Staff Report for PLPR-2607-0002

Application Type: MU-C Planning Review

Location of Subject: 4088 Haines Road

The applicant is proposing a 1-story, 5,050 sq. ft. bank with drive-through canopy.

SHEET INDEX

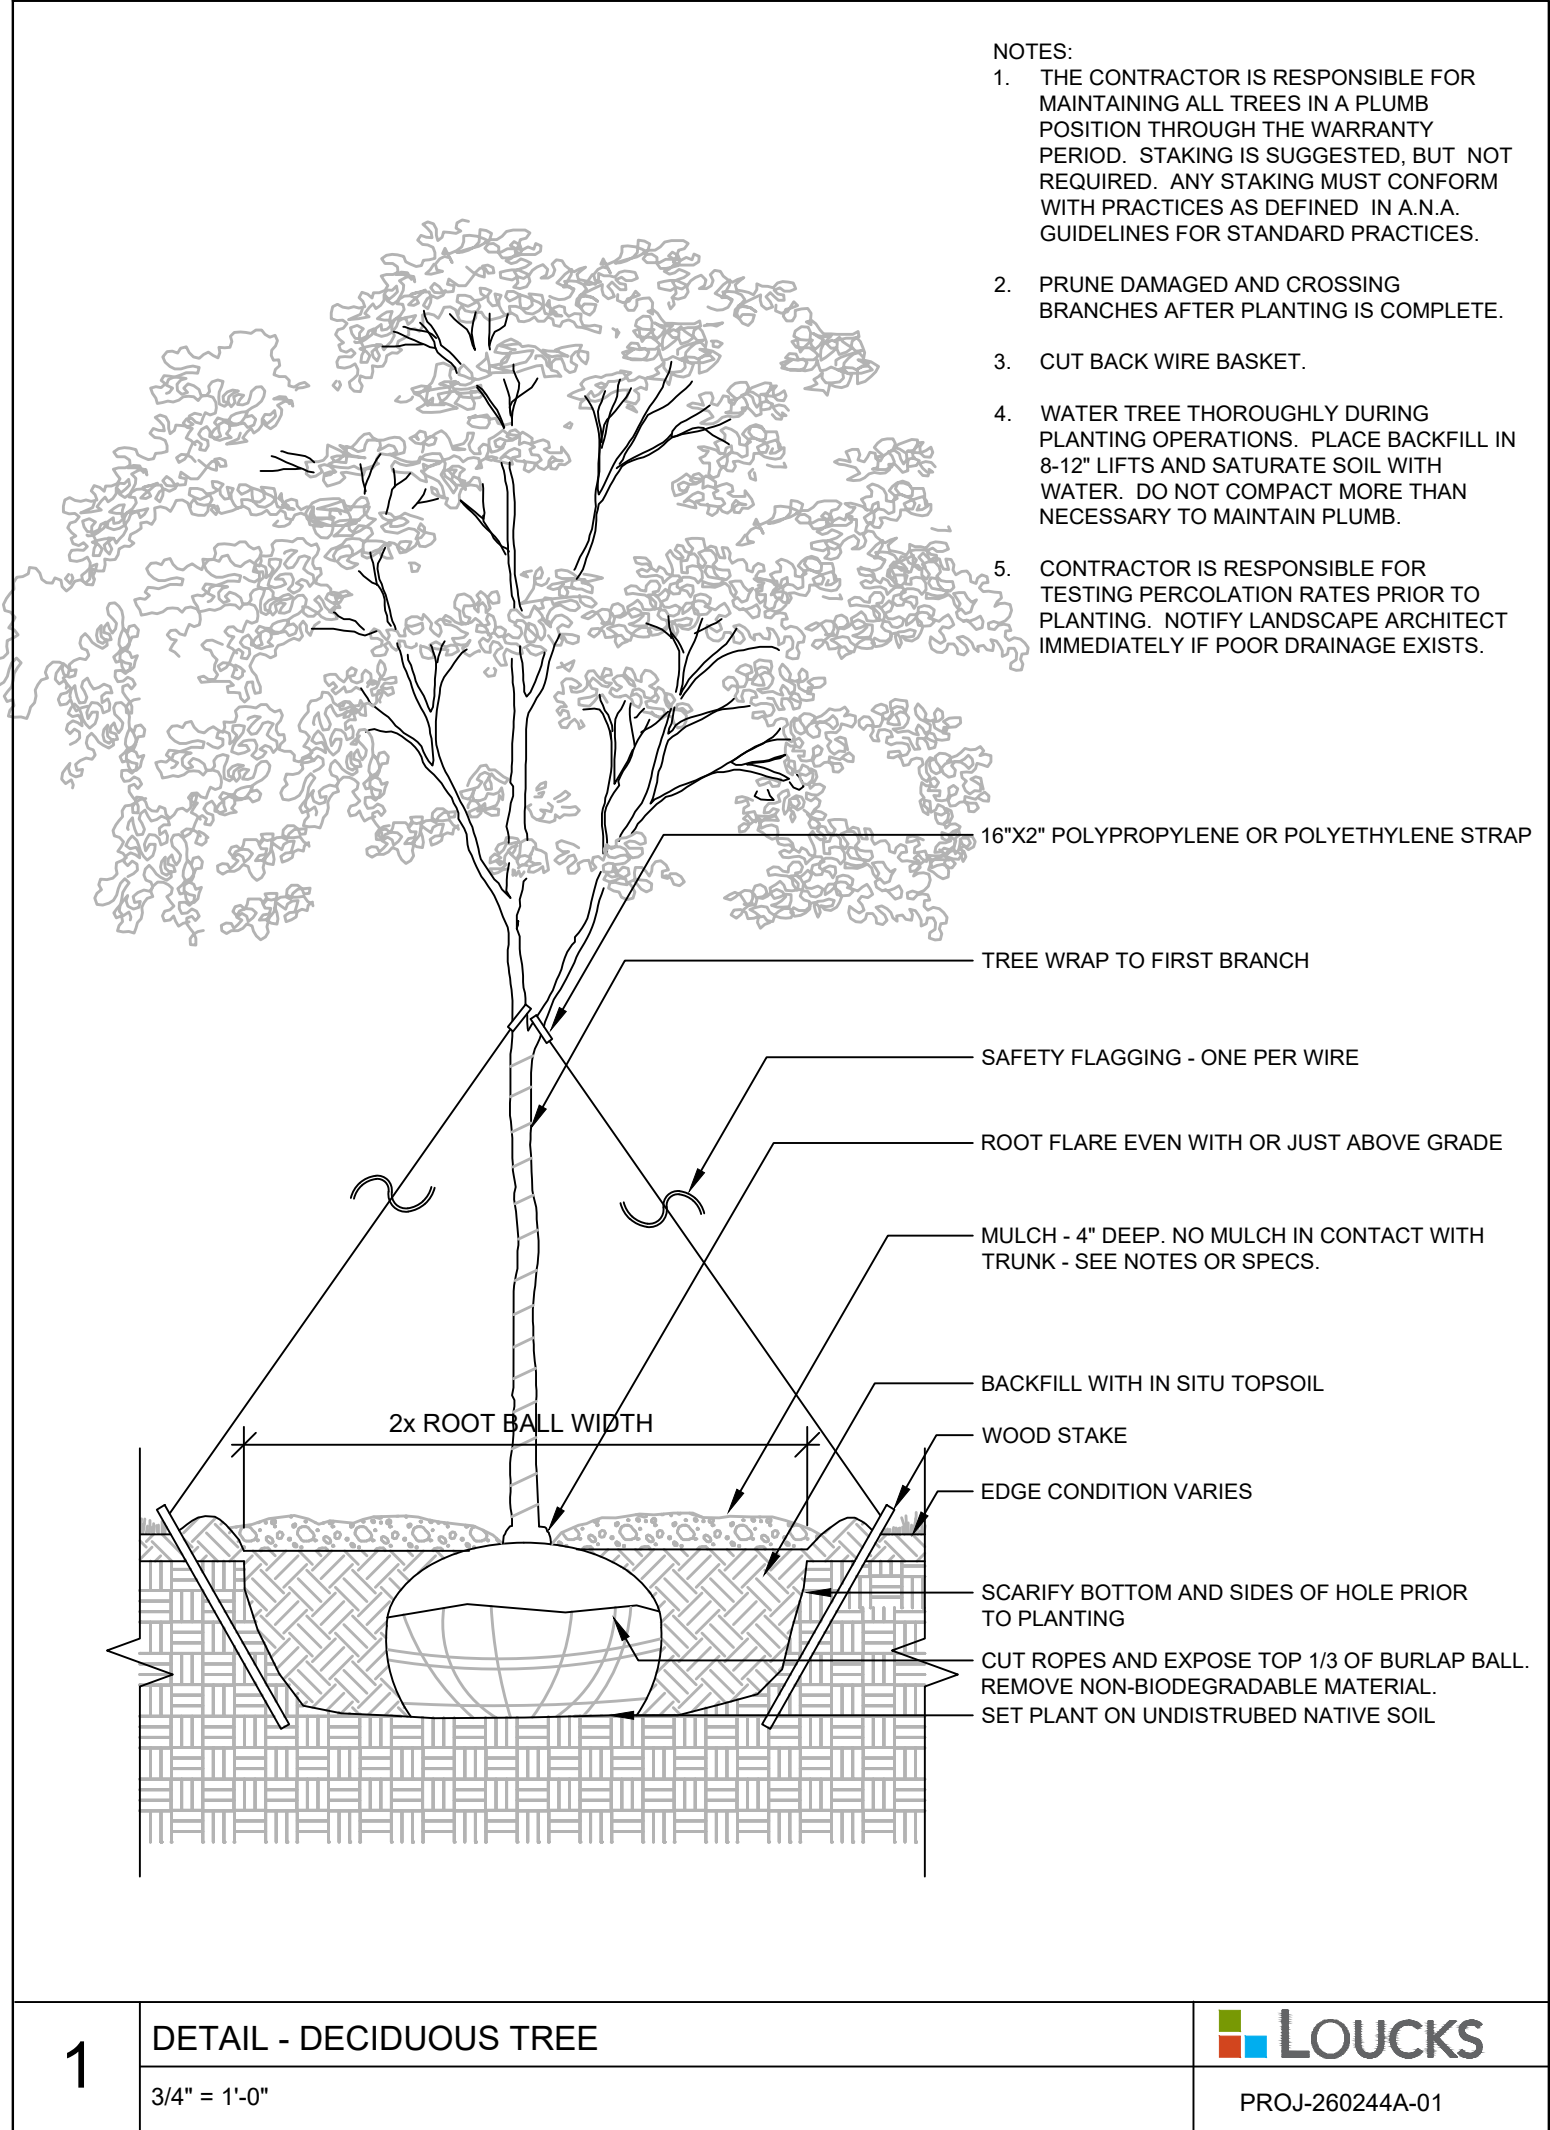
3. Section 50-22.3.E (Use Specific Standards, Bank) – The landscaping plan indicates there will be a dense urban screen between the drive-through and the adjacent residential property with a vegetative buffer as shown in the landscaping plan.
